ST. JOHNS RIVER WATER MANAGEMENT DISTRICT
ENVIRONMENTAL RESOURCE PERMIT #40-069-114354-1
RAI Submittal

HARTWOOD MARSH ROAD
PHASE II

Re: Hartwood Marsh Road—Phase II
1500 feet East of Hancock Road to Orange County Line
Application Number 40-069-114354-1
Response to Request for Additional Information

REVISIONS	
DATE	DESCRIPTION

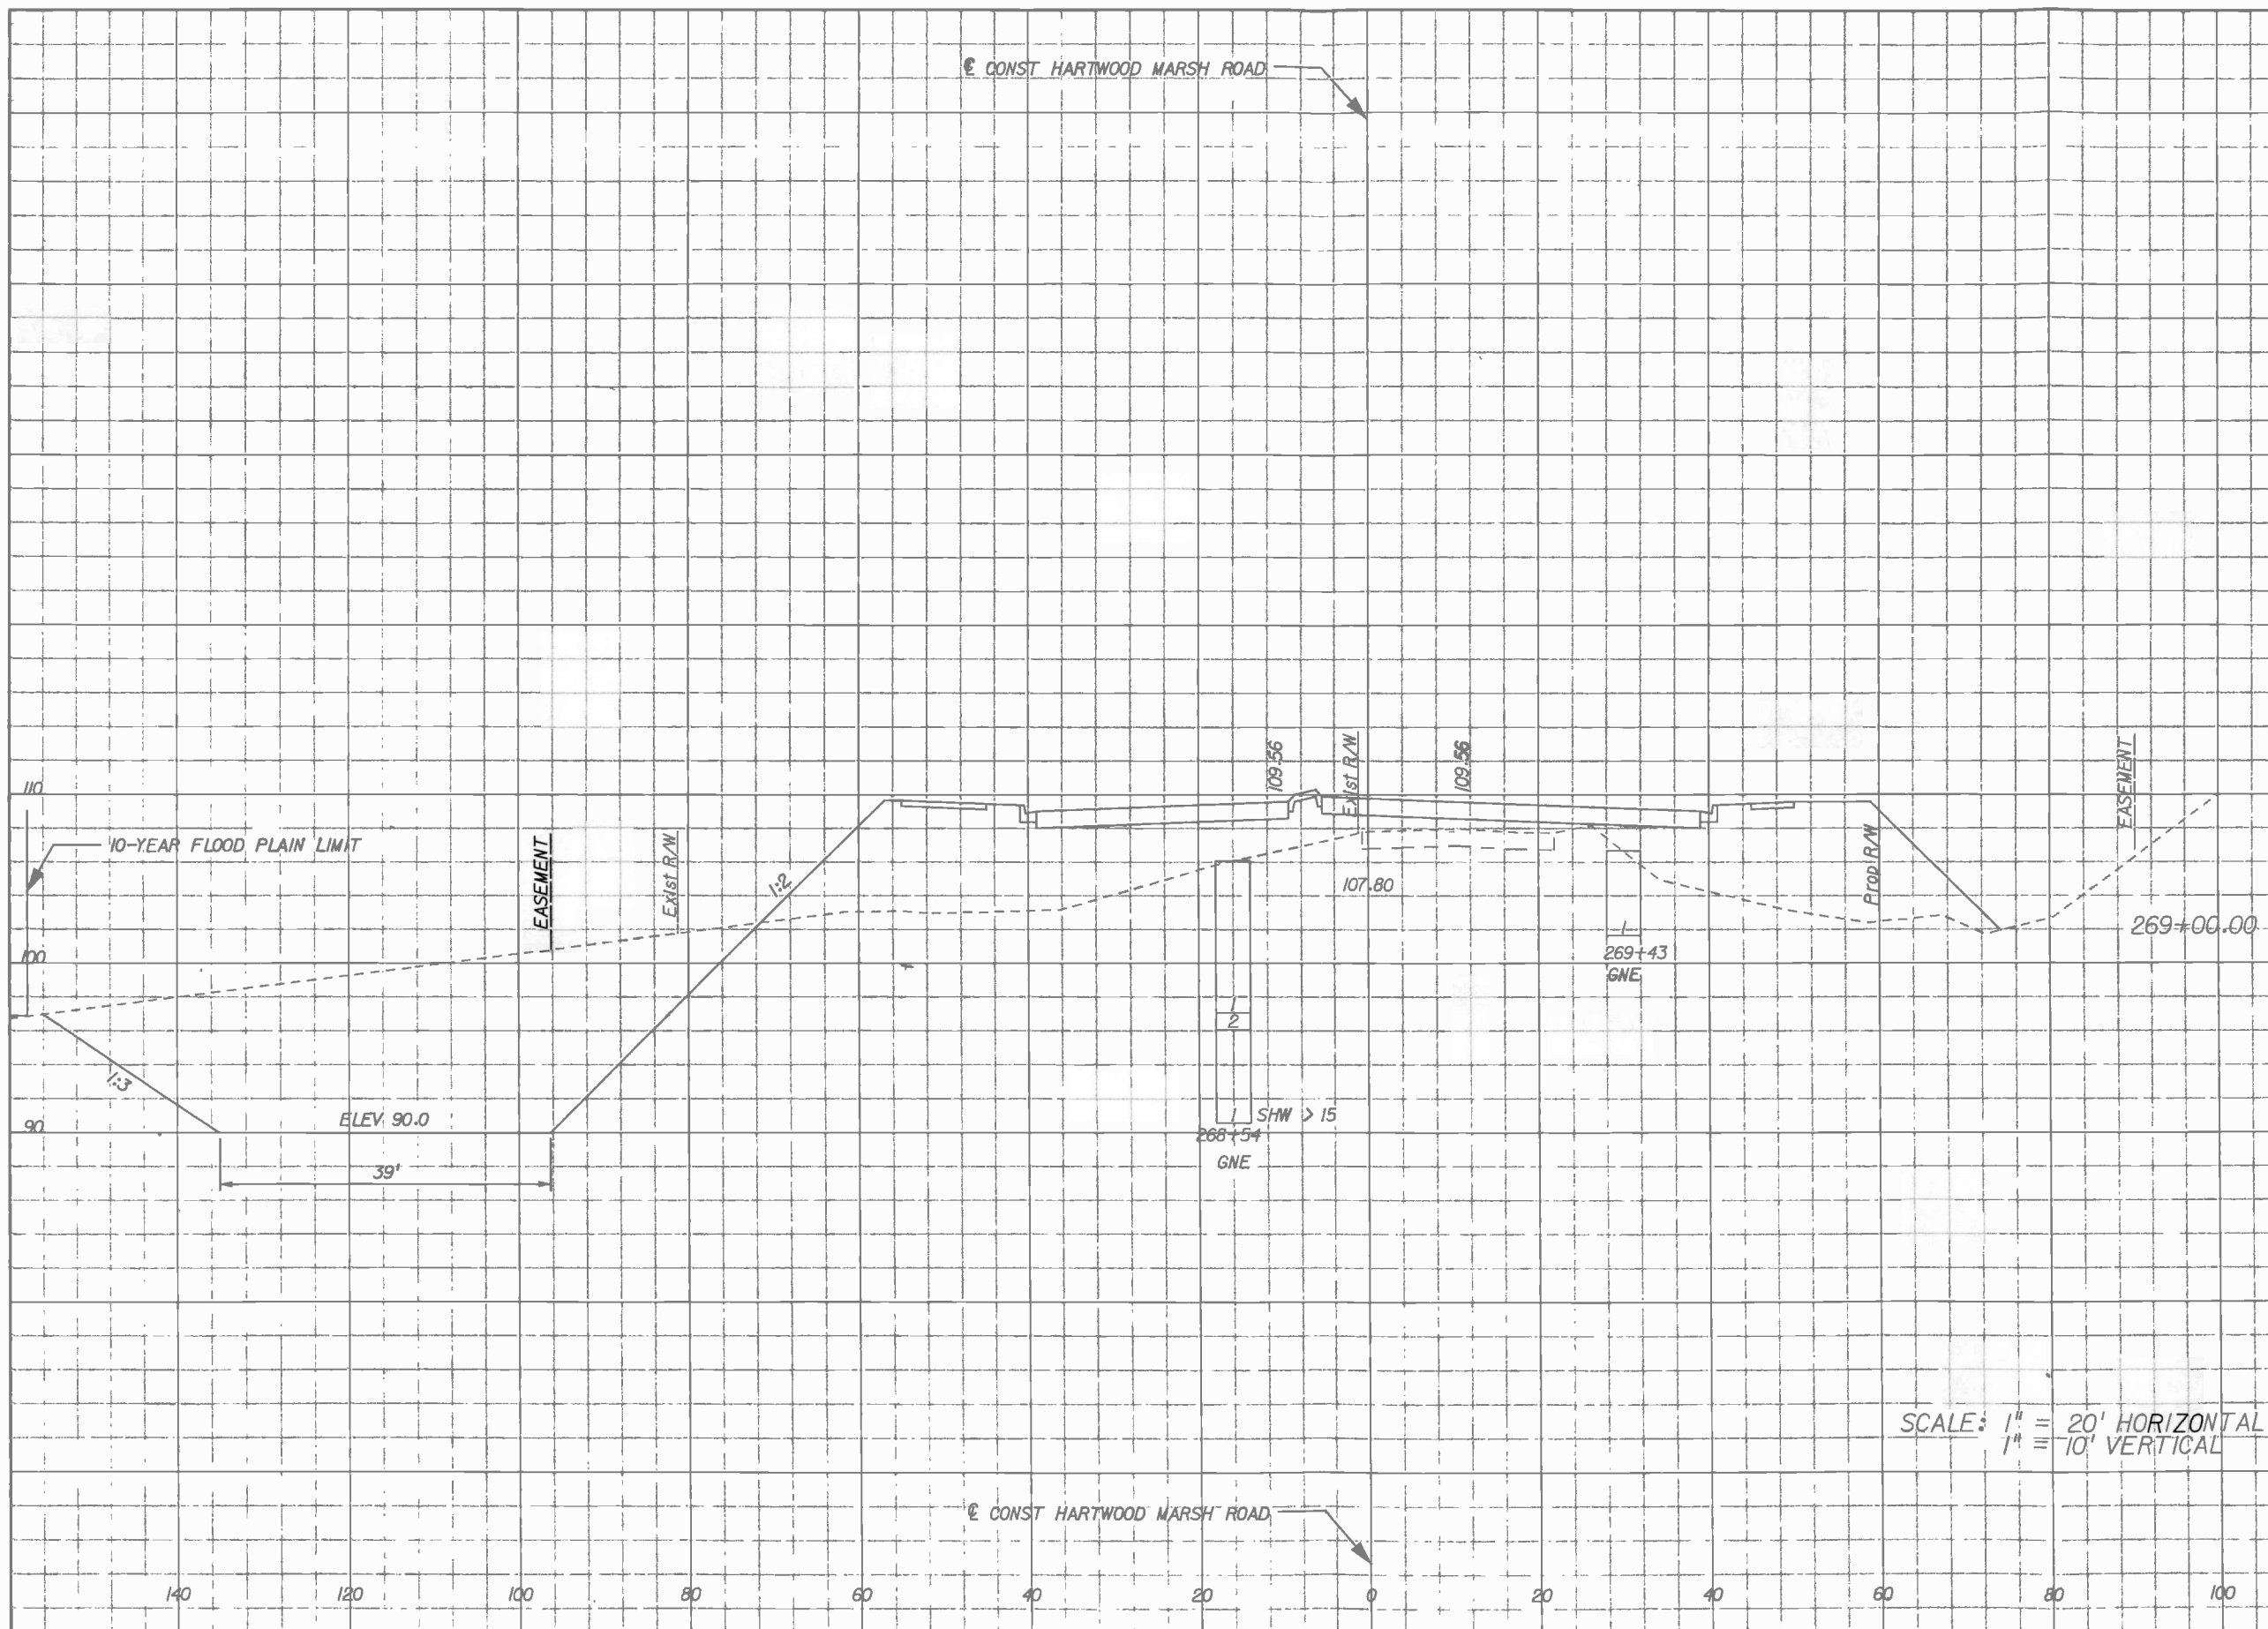
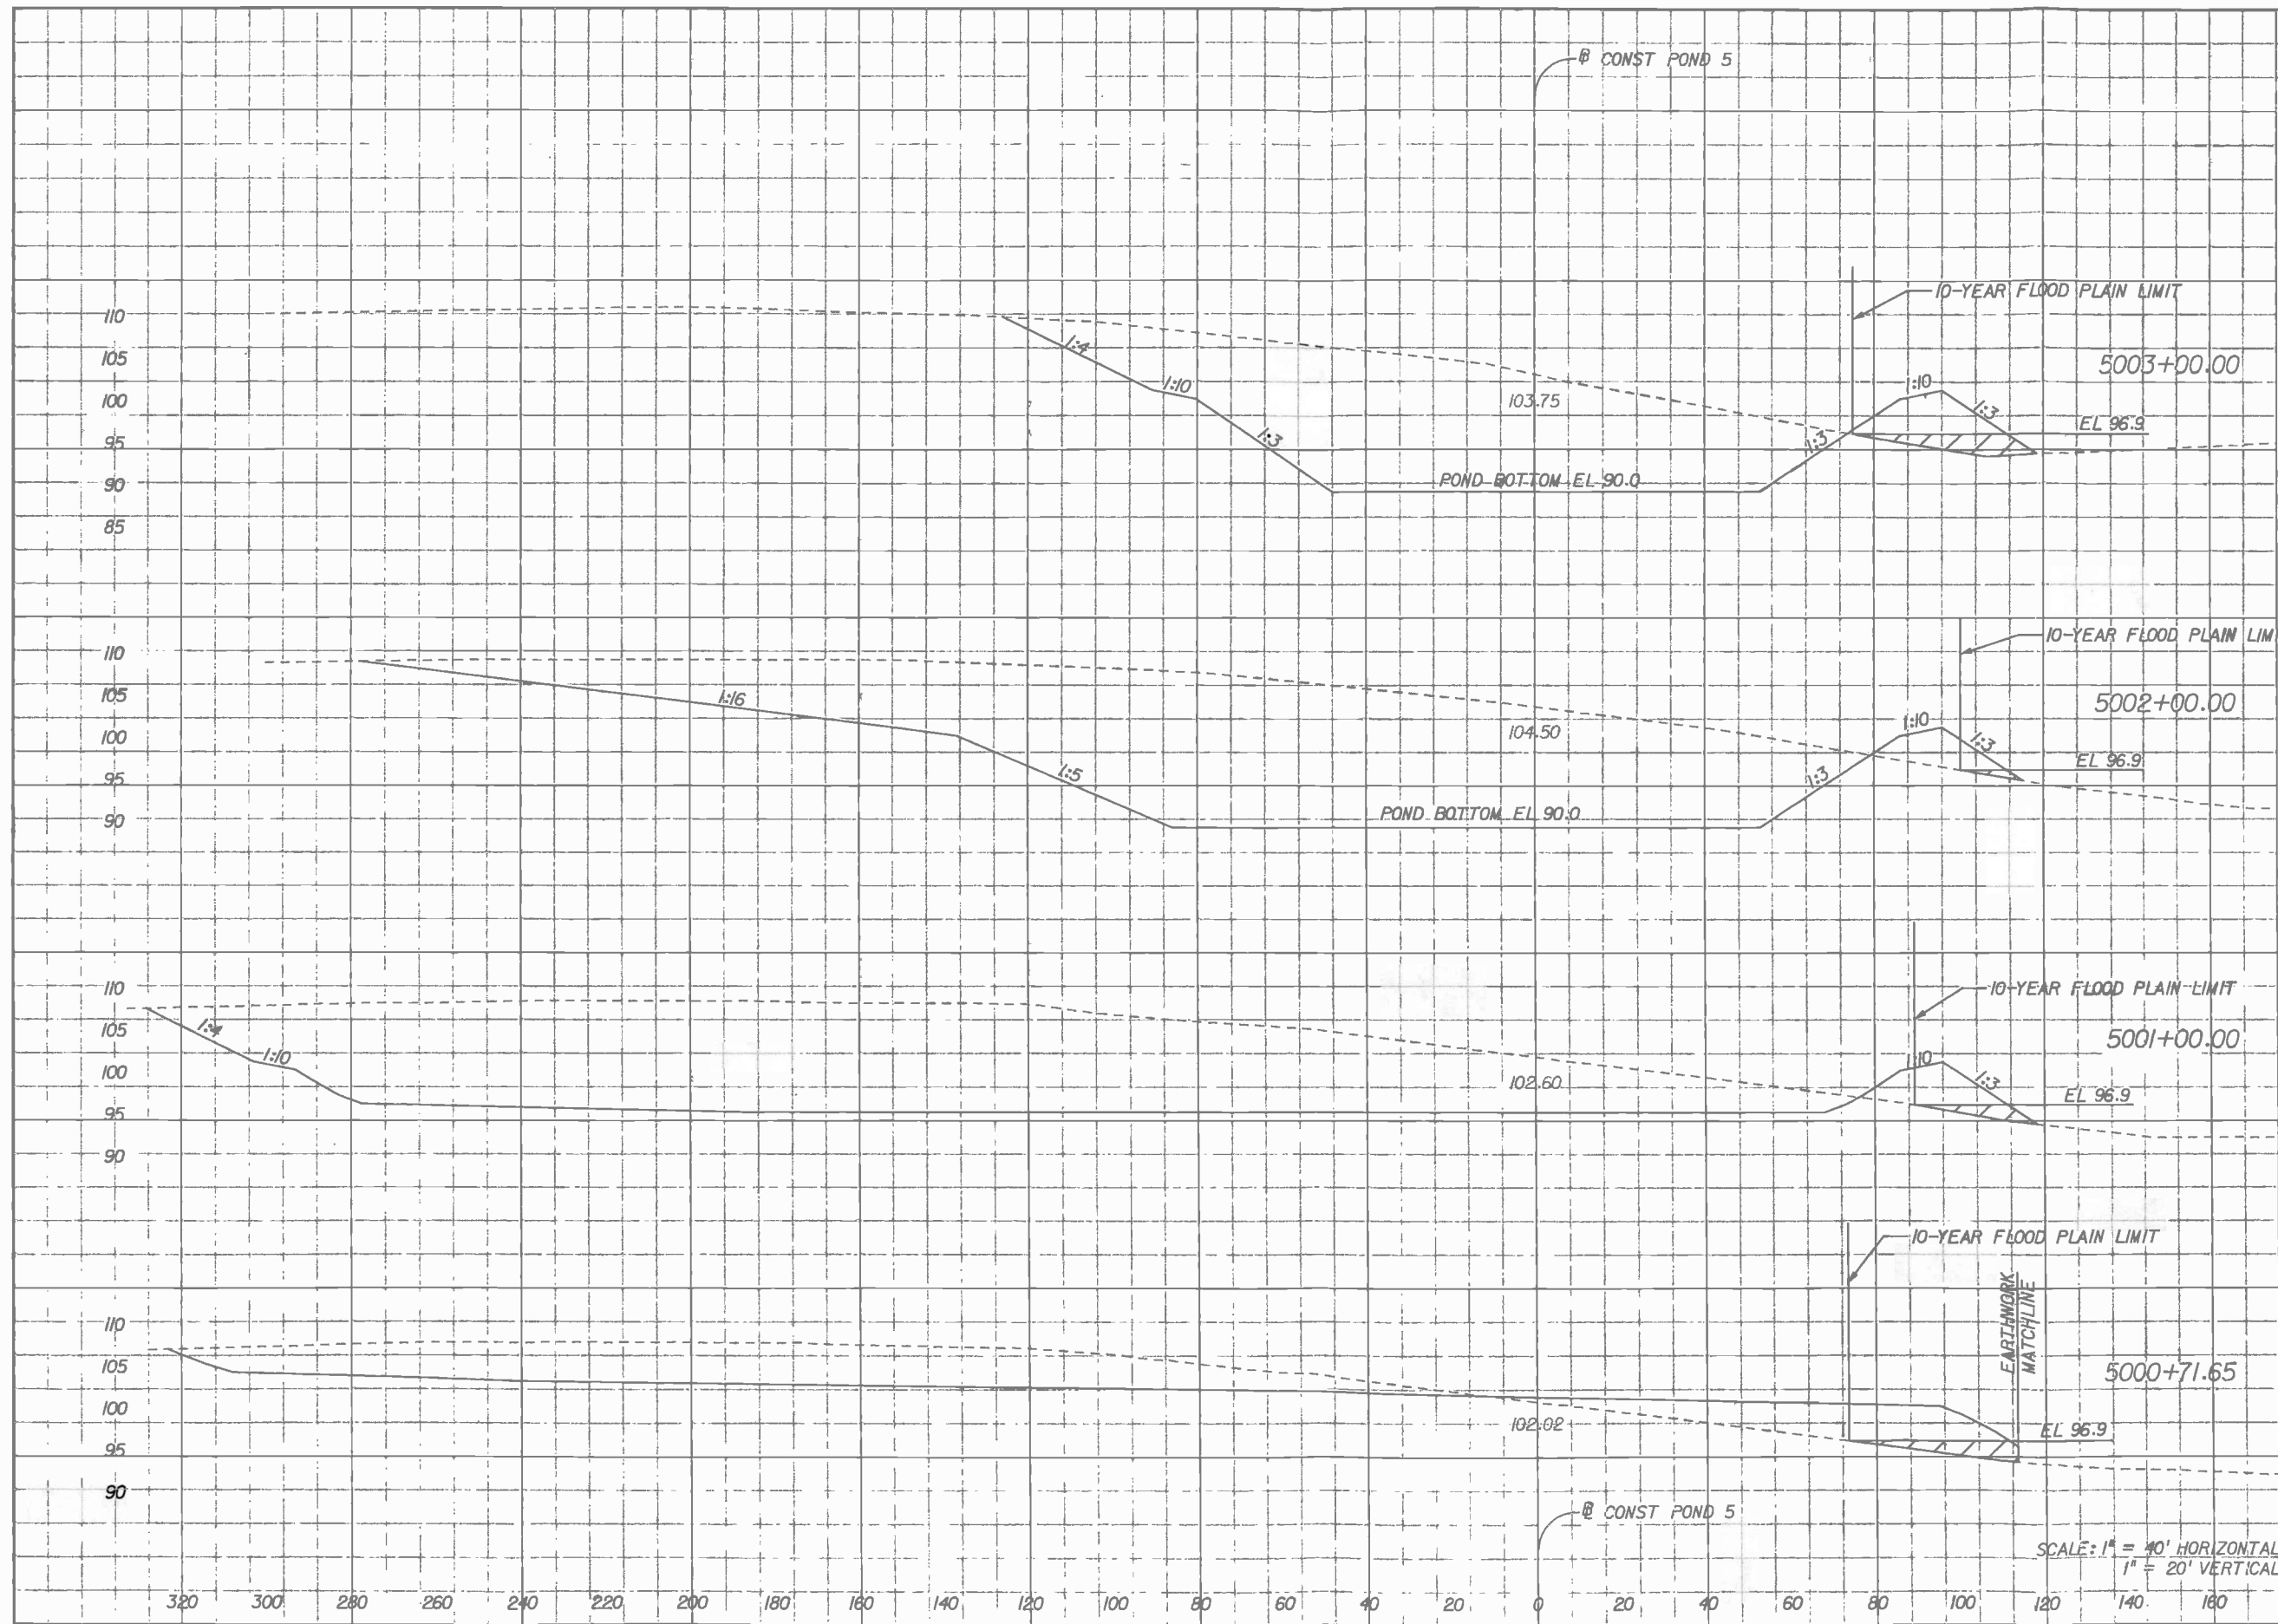
In addition, please provide cross-sectional view details for the compensating storage pond demonstrating that the pond is sufficiently sized to compensate for the fill impacts within the 10-year flood plain as shown in the cross-sectional view details on Pages 46 and 47 of the report. Please include supporting documentation for the SHWT elevation for the compensating storage pond, as previously requested, so that the compensating storage volume may be verified. Also, the compensating storage pond must have an open hydraulic connection to the floodplain encroached upon and the storage must be available during the flood event. The construction plans provided are not clear in this regard. Provide plan revisions and details, as necessary, for clarification.

Response: *The 10-year flood plain elevation of 96.9 feet NAVD for Johns Lake came from the 2002 FEMA Flood Insurance Study. The Summary of Stillwater Elevations table from the study has been included in the drainage calculations for reference. A pond detail sheet has been included for the compensation pond as well as calculations. Please refer to the drainage calculations.*
